Subject: New Push-In Style Speed Sensors

Document Number: TAIB0842

Date: November 19, 2012

Service Bulletin – Product

**X-8-460 – Input & Mainshaft Sensors
(MD output sensors)**

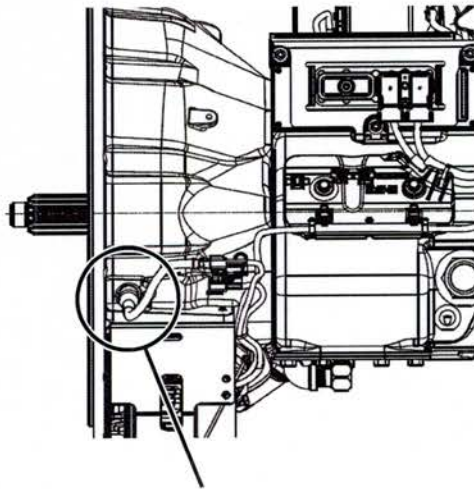
X-8-460:

- Replaces X-8C-409 (0.250" - 20 x 0.625")
- Use E8 external Torx drive socket for installation
- Torque spec is 4-6 lbs. ft. (6-8 Nm)
